ADDENDUM 001

project	IHC Wasatch Canyons B.H. Campus Bldg. E	project no	21690
date	2021-11-02	no. pages	
owner			
contractor			
bid date	2021-11-04	bid time	2:00 pm

A3 PLAN - LEVEL 01 - FINISH

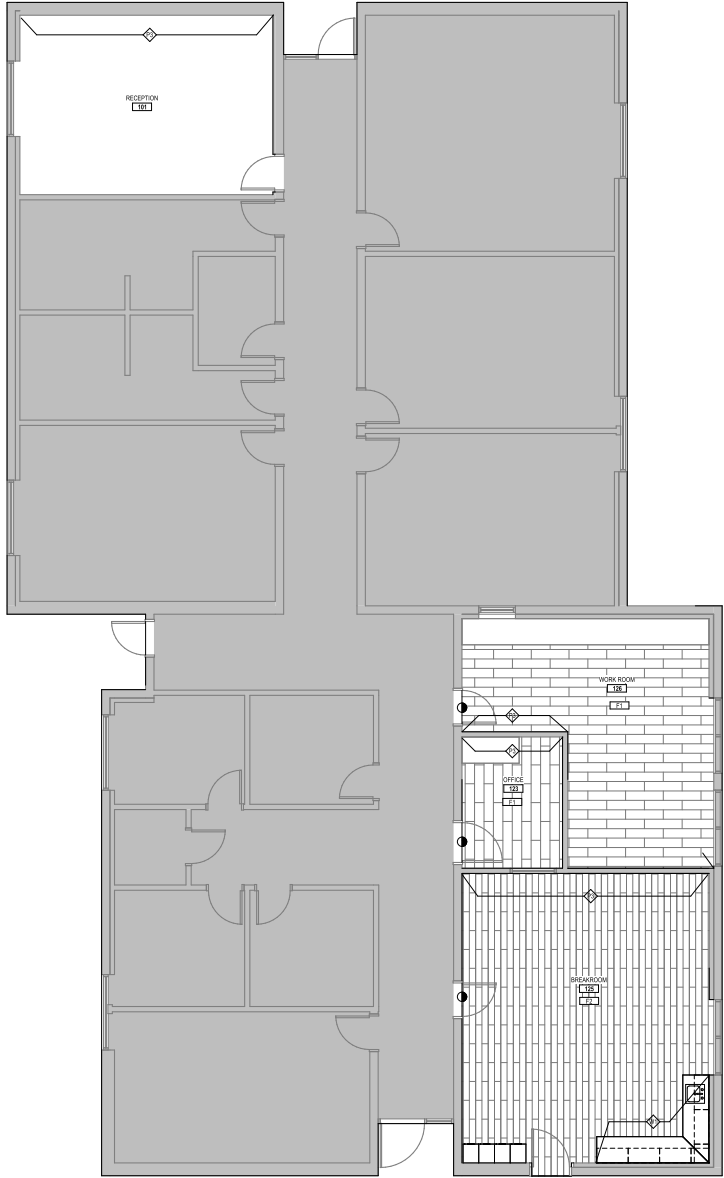
1. Can we find out what is to be used for the counter top. Two laminates listed on finish schedule without reference to where each goes.

1. Can we find out what is to be used for the counter top. Two laminates listed on finish schedule without reference to where each goes.

1. Surface type S1 (LAMIN-ART, MYSTIC WOOD) to be used over horizontal surfaces - countertops. Surface type S2 (WILSONART, PHANTOM COCOA) to be used over vertical surfaces - cabinets.
2. Refer to revised sheet A110.3 FINISH PLAN - LEVEL 01.

1. Surface type S1 (LAMIN-ART, MYSTIC WOOD) to be used over horizontal surfaces - countertops. Surface type S2 (WILSONART, PHANTOM COCOA) to be used over vertical surfaces - cabinets.
2. Refer to revised sheet A110.3 FINISH PLAN - LEVEL 01.
